ADDENDUM NO. 1  
SEWERAGE SYSTEM IMPROVEMENTS  
CONTRACT 16-01  
PEAK WASTEWATER FLOW DIVERSION  
PUMPING STATION MODIFICATIONS  
CLEVELAND UTILITIES  
CLEVELAND, TENNESSEE  
CU PROJECT NO. S2683X  
WAUFORD PROJECT NO. 4626

Date of Addendum: Wednesday, April 5, 2017

SHEET **2** OF **8**

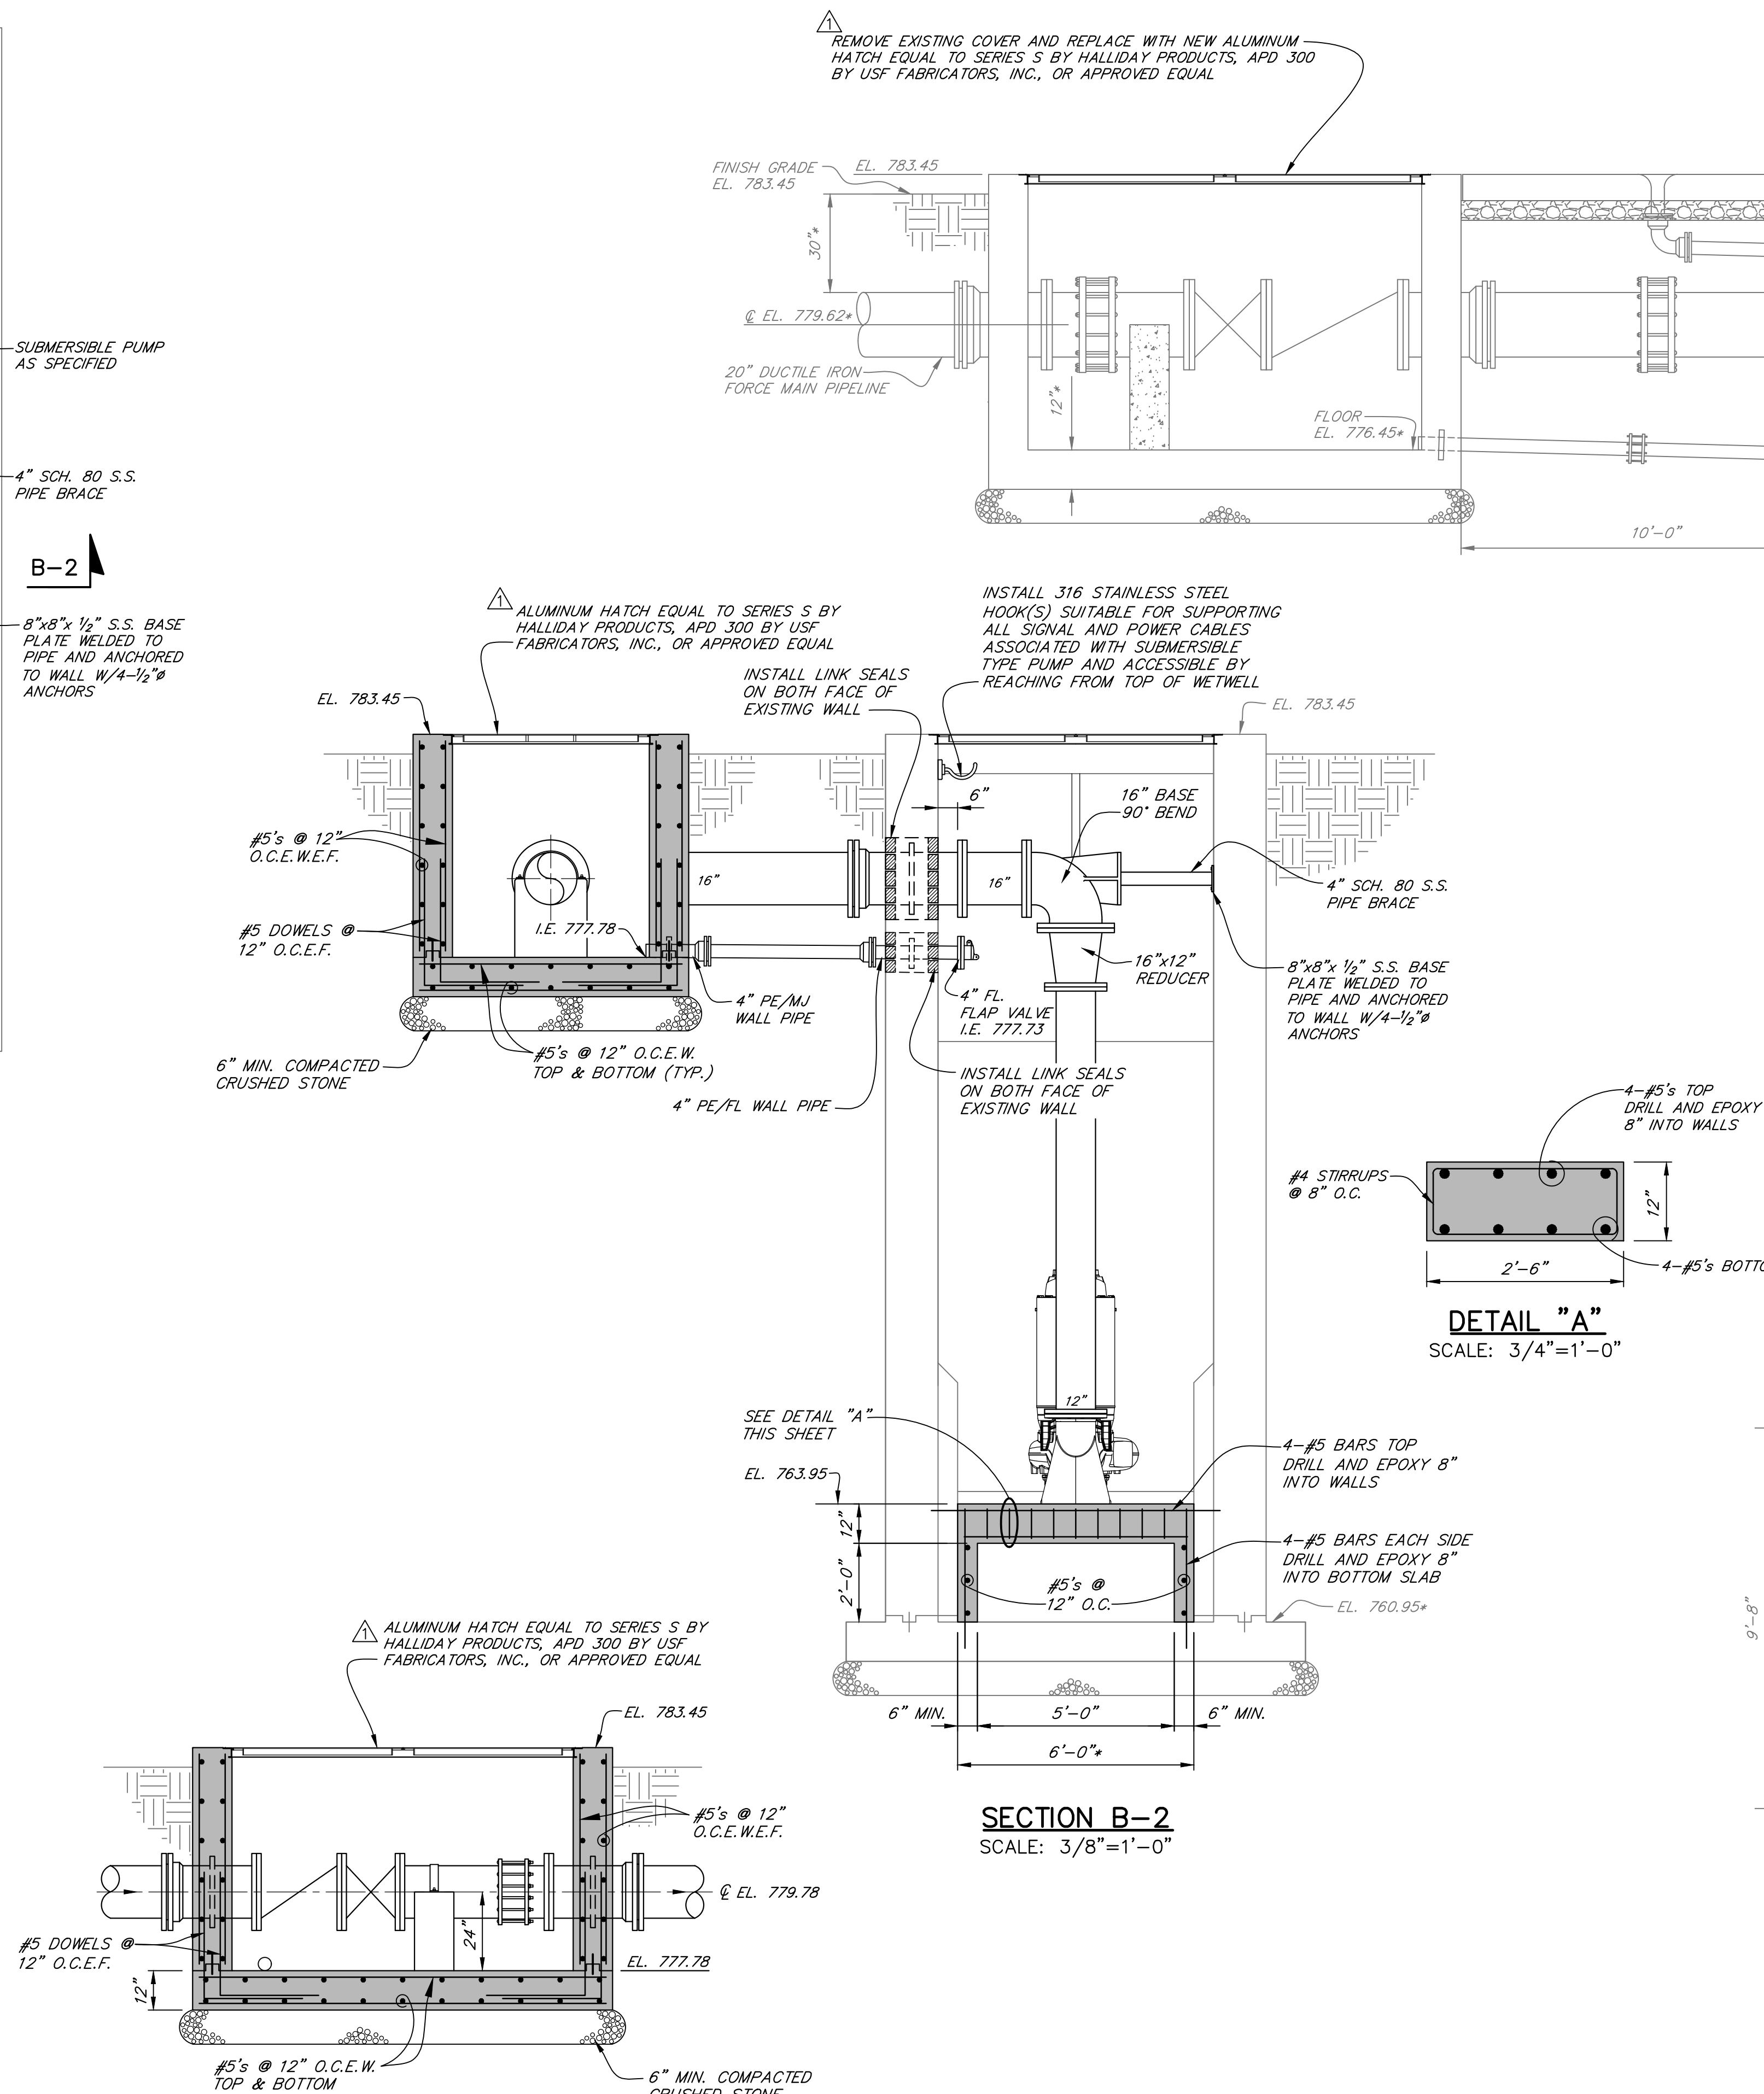
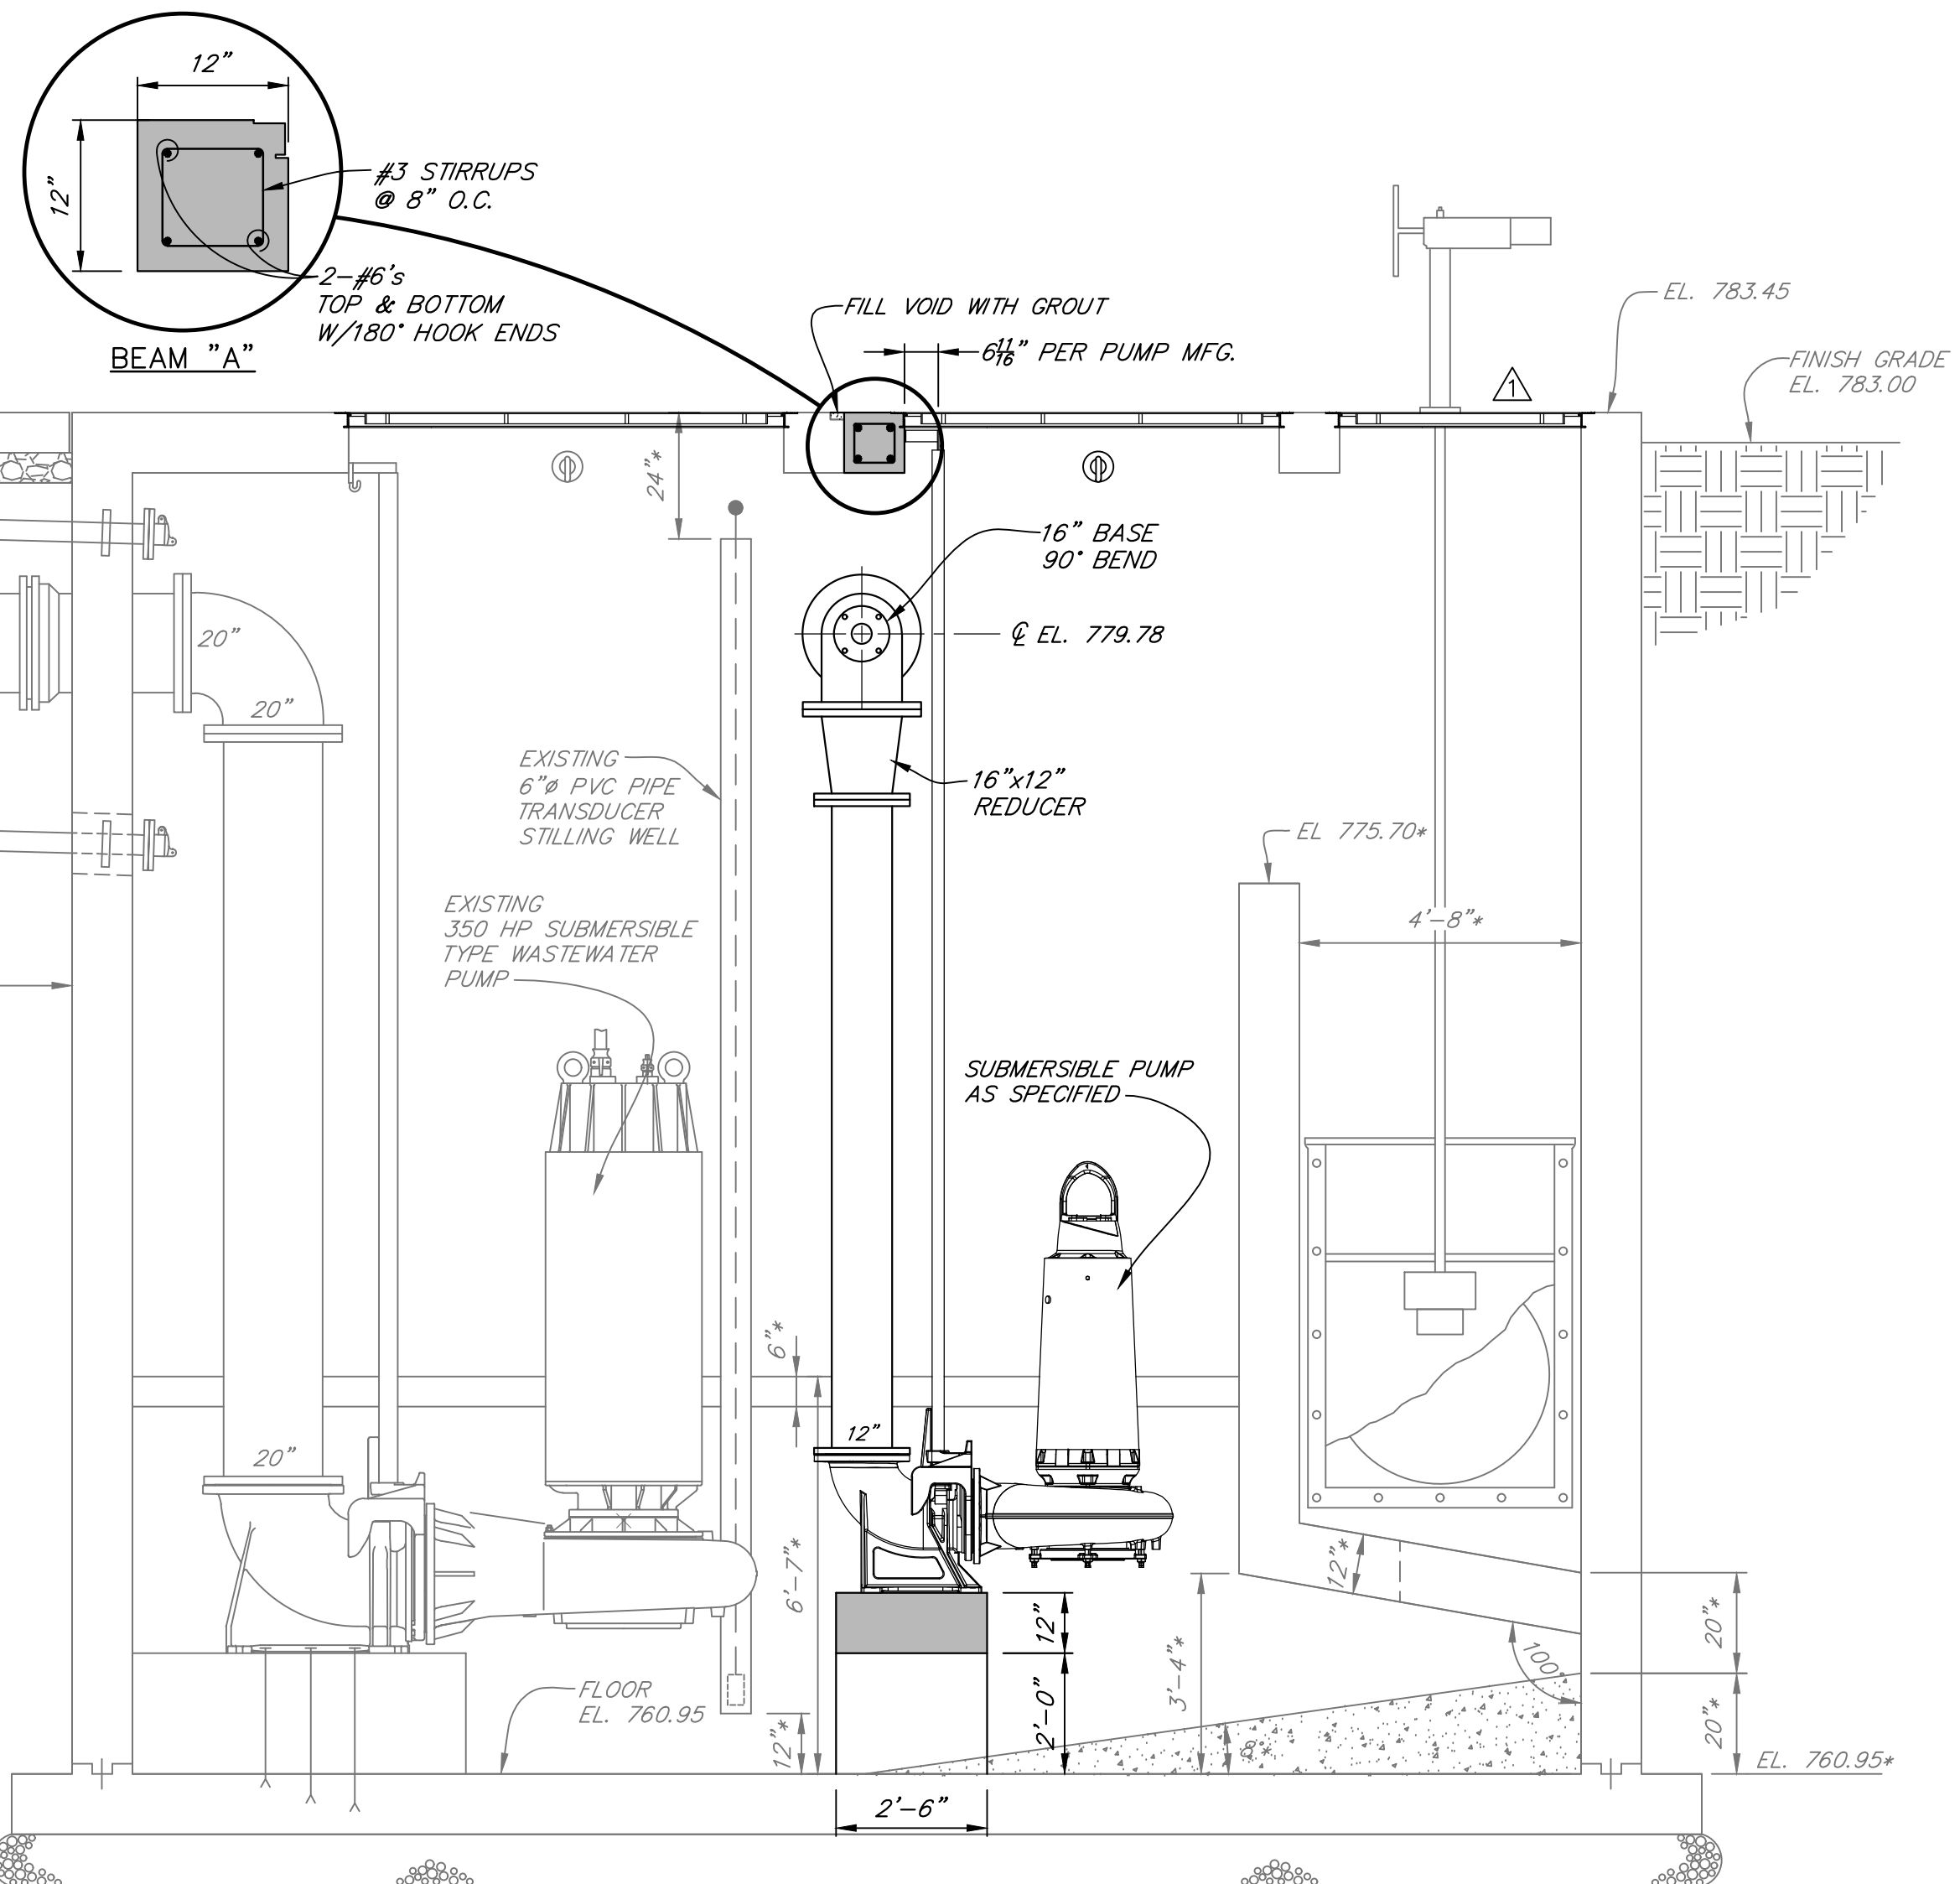
6. Plans, Sheet 1:  
Revise as shown on attached Plans, Sheet 1.
7. Plans, Sheet 2:  
Revise as shown on attached Plans, Sheet 2.
8. Plans, Sheet 3:  
Revise as shown on attached Plans, Sheet 3.
